ARCOS BULLETIN 2013-3

SUBJECT: IT Design Criteria Updates

USARC G-6

IT Design Criteria Updates

Figure 5.1

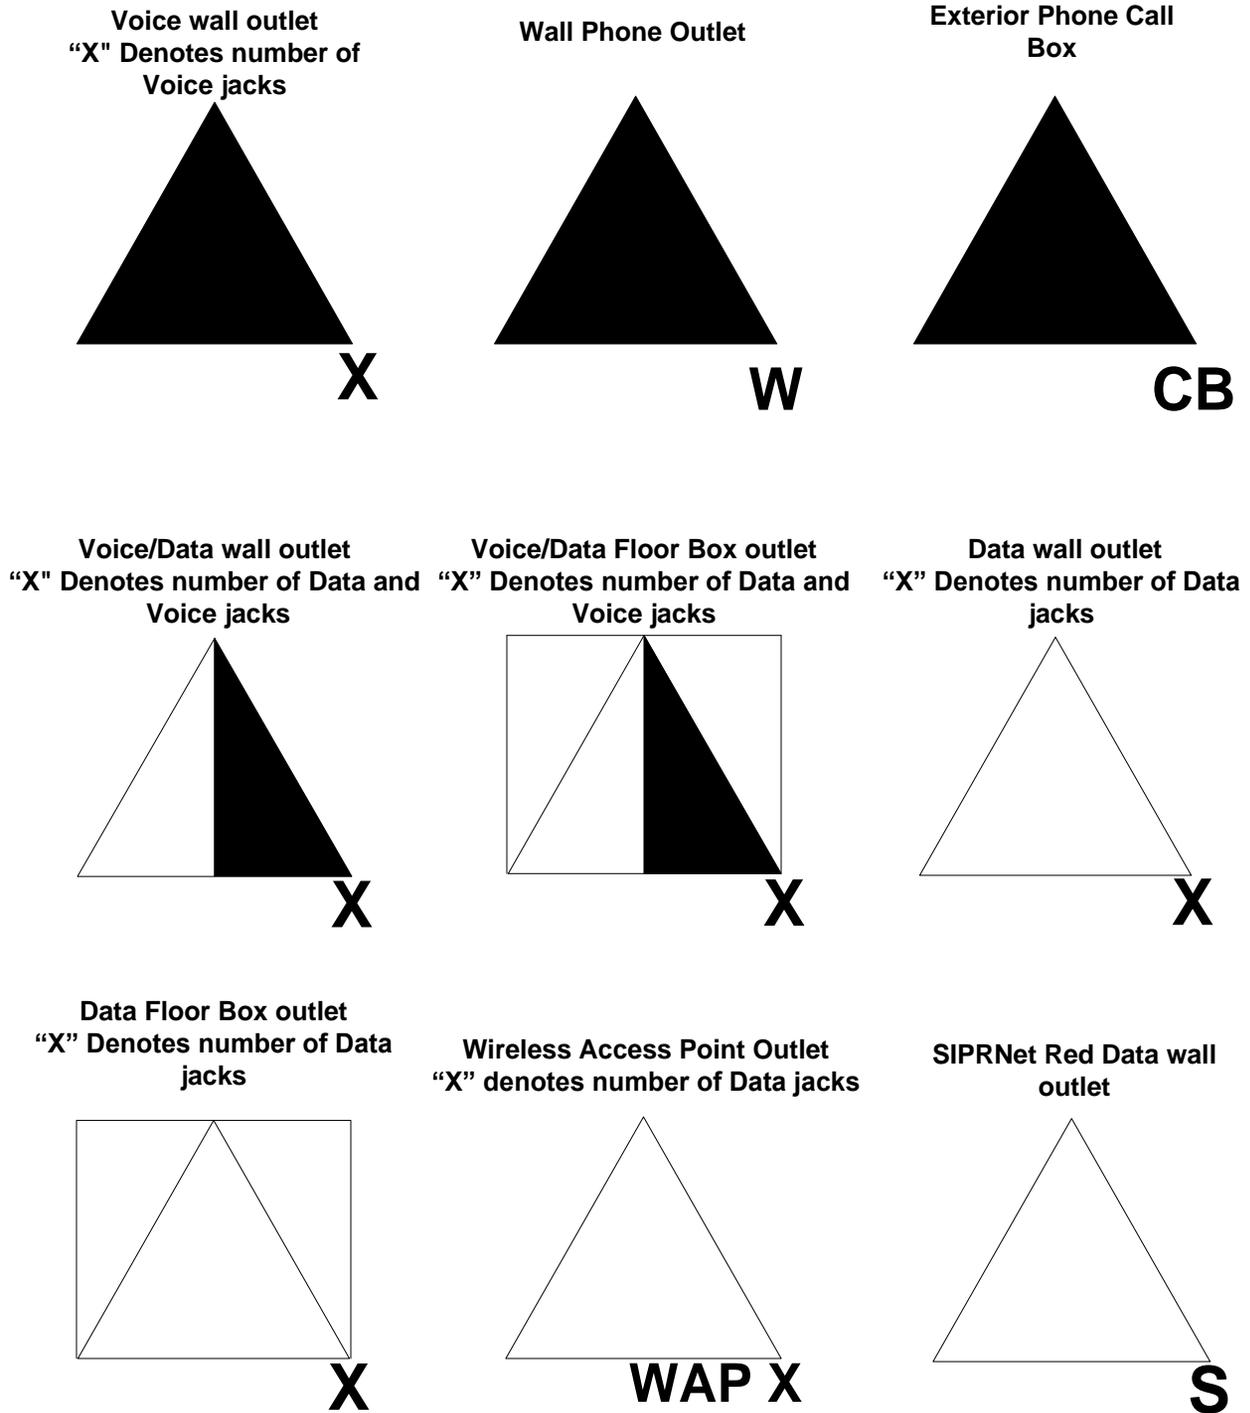
- 4.1.11. USARC G-6 has developed a Standard Telecommunications Symbols Legend. This legend (see Section 5 Figure 1 of this document) is required to be used as the basis of design for the IT DOR's Telecommunications Symbol Legend.
- 4.1.12. Cable requirements from the TER to the UHS have been reduced. Only 6 pair of OSP copper cable is now required. There is no requirement for Fiber Optic cable.
- 4.1.13. Clean Power circuits as referenced in the Army Reserve IT Manual are no longer mandated. Where clean power circuits are referenced, power circuits are still required. The Electrical DOR shall design the electrical system to reduce or eliminate harmonics IAW current codes, standards, and best practices.
